## Service Bulletin: 1202002SR: Spacing of Wing to Fuselage attachments

### SR-3500 SERIES AIRCRAFT

This bulletin affects all SR-3500 series aircraft including kit and fast built units.

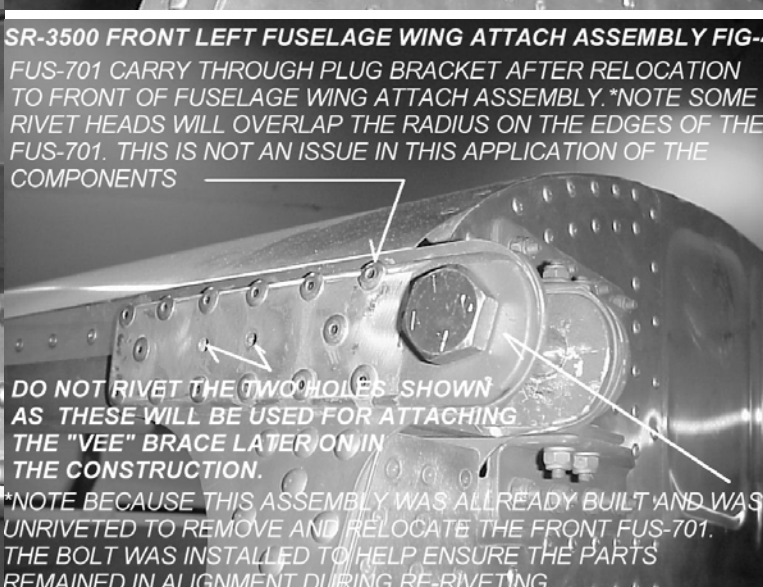
The fitting of the SR3500 series wings to the modified SR3500 fuselage front wing attach fittings has caused an unacceptable interference fit on two fast-build aircraft being assembled at the factory.

The illustration in Fig 1 below shows the nature of the problem. The "Outside" fore to aft spacing of the W-710 & W-709 front attach brackets to the W-713&W-714 rear attach brackets on the wings, exceeds that of the fuselage receiver fittings spacing. Uncorrected the resulting fore and aft pre-loads on the rear wing attach fittings will cause them to bend. This must be corrected prior to fitting the wing to the fuselage. The rear wing attach fittings must be completely free of fore and aft pre-load during assembly. This is accomplished by adjusting the fit and location of the combined W-710 and W709 fittings within the front fuselage wing attachments. See fig 2 below.
